REPORT ON KOMENDA SUGAR FACTORY

REPORT ON THE KOMENDA SUGAR DEVELOPMENT COMPANY LIMITED

Fig. 1: Total area of Cane Nursery

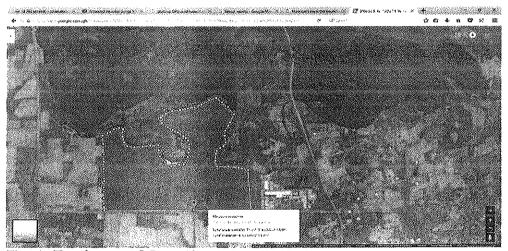
- 24. The total fenced area earmarked for the nursery development is 63.4 Ha (158 acres). The Cropped area is 49.94Ha and out of this, 0.5ha is saline. The remaining land area is covered by the roads in the nursery. Some of the plants showed stunted growth and empty patches. There was a wide variation in the height of sugarcane on the same plot. The empty spaces were not filled thus reducing the expected plant population per hectare. However, other parts of the nursery showed strong and vigorous growth. It should be noted that none of the sugarcanes in the plots can be planted as plant cane this year since the planting date (May-June-July) is already past.

- 25. About 97% (48.8ha) of the cropped area is composed of the B41227 variety which is prevalent in the Komenda area. Investigations show that no variety selection was conducted since a period of 7-8 months was given as the duration for the nursery operation which was not enough for proper crop selection. Brix levels which were taken at the time of the study, the B41227 variety was 17.5% whiles, CO2014-001, CO86032, KI, K2 had brix levels of 22.5%, 19.1%, 21.8%, 21.6%, respectively.
